<b>Title of Change:</b>	AR0238 Datasheet Update
<b>Effective date:</b>	12 Feb 2020
<b>Contact information:</b>	Contact your local ON Semiconductor Sales Office or Sonya.Yip@onsemi.com
<b>Type of notification:</b>	This Product Bulletin is for notification purposes only. ON Semiconductor will proceed with implementation of this change upon publication of this Product Bulletin.
<b>Change Category:</b>	Documentation Change
<b>Change Sub-Category(s):</b>	Datasheet/Product Doc change
<b>Sites Affected:</b>	
<b>ON Semiconductor Sites</b>	<b>External Foundry/Subcon Sites</b>
None	None

Updated case outlines (package drawings) in the AR0238CS datasheet with the latest revisions.

#### 1. Updated CASE 776AQ

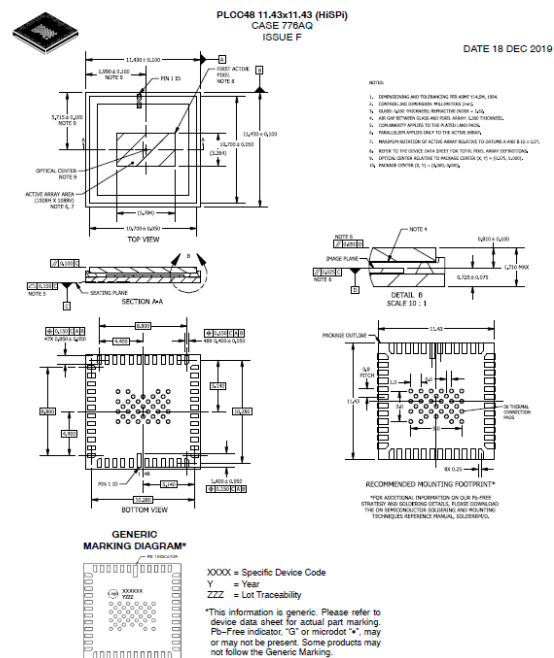
##### Old Revision D

##### New Revision F

PL0048 11.43x11.43 (Parallel)  
CASE 776AS  
ISSUE A

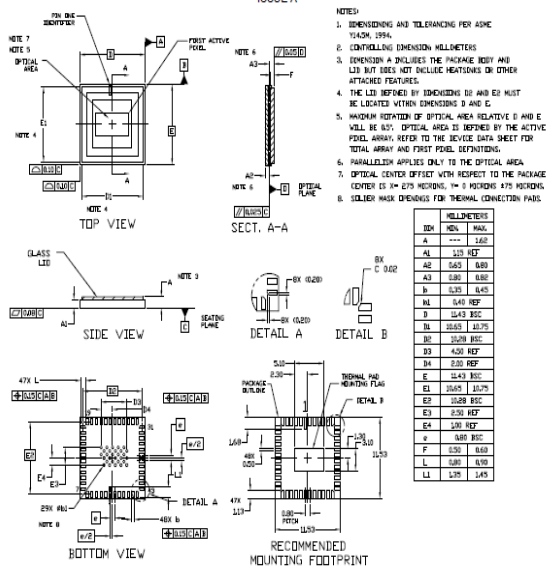
## 2. Updated CASE 776AS

### Old Revision A

PL0048 11.43x11.43 (Parallel)  
CASE 776AS  
ISSUE D

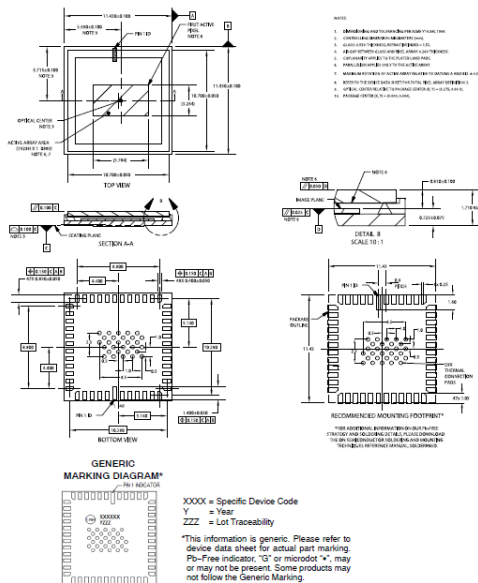
### New Revision D
